Pentest-Report Nitrokey Storage Hardware 08.2015

Cure53, Dr.-Ing. Dmitry Nedospasov, Dr.-Ing. Mario Heiderich

Fig.: Atmel Device Programming GUI. Note that the BOD is disabled.

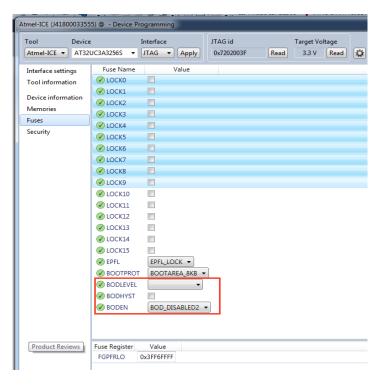
NK-02-005 Brown Out Detection Not Enabled (High)

The BOD fuse bits are not set on the Nitrokey. The AT32UC3A3256S contains multiple Brown Out Detectors (BOD).⁷ These can be used to detect abnormalities in the supply voltage. Tampering with the supply voltage is commonly performed to inject faults during execution. Enabling the BOD ensures that the system resets upon detecting a brown out condition. This makes the analysis more difficult for the attacker.

It is recommended for the BOD to be enabled in hardware by setting the BODEN fuses to 0x1. The result of this operation will be "BOD enabled, BOD reset enabled". Because the Nitrokey is powered over USB, the BODLEVEL can be set to a narrow operating band. Moreover, the BOD33 should be configured in software for the purpose of monitoring supply voltage and initiating device resets.

Note: This issue was fixed by the Nitrokey maintainers, the fix was verified by Cure53.
